# UNITED STATES PATENT AND TRADEMARK OFFICE

APPLICATION NO.	FILING DATE	FIRST NAMED INVENTOR	ATTORNEY DOCKET NO.	CONFIRMATION NO.
10/067,828	02/08/2002	Satoshi Kume	011776	3040

## Office Action Summary

**DETAILED ACTION**

zone (which it is in Kume et al.) as seen in the attached figure 8.

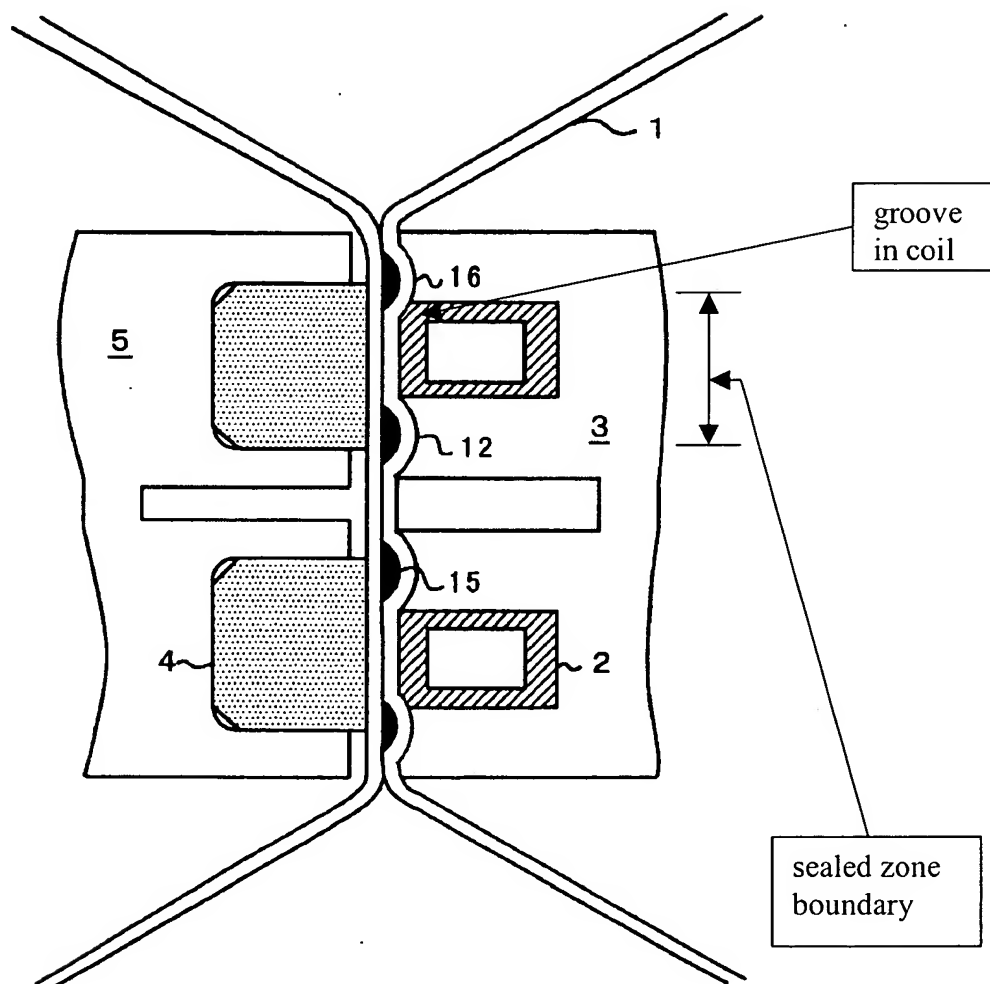
The Kume et al. reference meets the claimed structure set forth in claims 1, 2 and 4; in Kume et al. there is shown a container sealer (figures 8, 11 and 12), and which sealer is described in col. 6, line 1 through col. 7, line 58. The Kume et al. reference shows a groove (16) and a flash portion (12, 15). Figure 8 shows that the depth of the groove is no greater than one half of its width. Claim 1 is anticipated because the claim requires that the high-frequency coil forms a flat action face (which Kume et al. does), and that the groove be in the action face of the pressing member with the high-frequency coil (which Kume et al. has, as seen in figure 8), and that the groove formed in the high-frequency coil is within the sealed

9. Applicant's arguments filed 20 February 2004 have been fully considered but they are not persuasive. Applicant has argued that the Kume et al. reference does not anticipate the subject matter of claim 1 because the groove is not within the sealed zone, but such is clearly not the case as is described above in the rejection and with particular reference to the reproduced figure. Assuming that a reference is properly "prior art," it is only necessary that the claim(s) under consideration "read on" something disclosed in the reference, i.e., all limitations of the claim are found in the reference, or "fully met" by it. *Kalman v. Kimberly-Clark Corp.*, 218 USPQ 781. Anticipation under 35 USC 102 is established when a single prior art reference discloses, either expressly or under the principles of inherency, each and every element of a claimed
